The Atomic Energy Commission has issued Amendment No. 5 (Change No. 6) to License No. DPR-33 and Amendment No. 2 (Change No. 6) to License No. DPR-52 (copies enclosed) for Browns Ferry Nuclear Plant Units 1 and 2, respectively.

TENNESSEE VALLEY AUTHORITY DOCKET NO. 50-259 (BROWNS FERRY NUCLEAR PLANT, UNIT 1) AMENDMENT TO FACILITY OPERATING LICENSE

CHANGE NO. 6

SAFETY EVALUATION BY THE DIRECTORATE OF LICENSING SUPPORTING AMENDMENT NO. 5 TO DPR-33

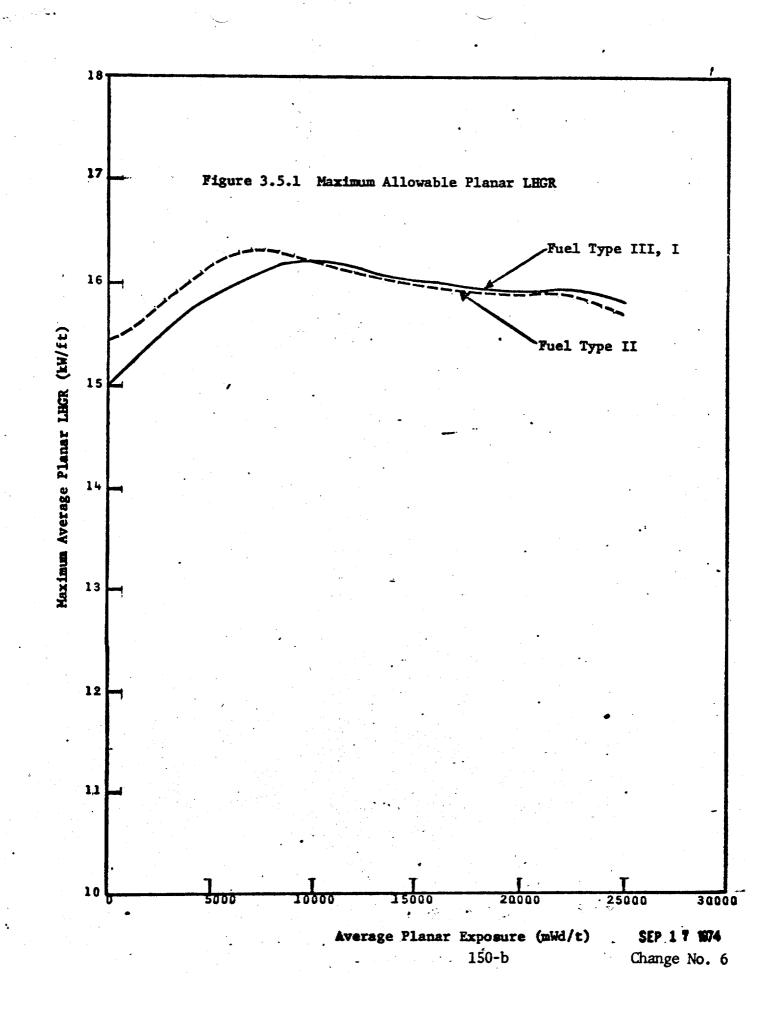
1. Delete the first paragraph on page 150 and replace with the following:

"The maximum average planar LHGR shown in Figure 3.5.1 is based on calculations employing the GEGAP III model described in the General Electric report NEDO - 20181, Revision 1. page 157."

2. Delete the existing Figure 3.5.1 Maximum Allowable Planar LHGR (page 150-b) and insert the revised Figure 3.5.1 attached hereto.
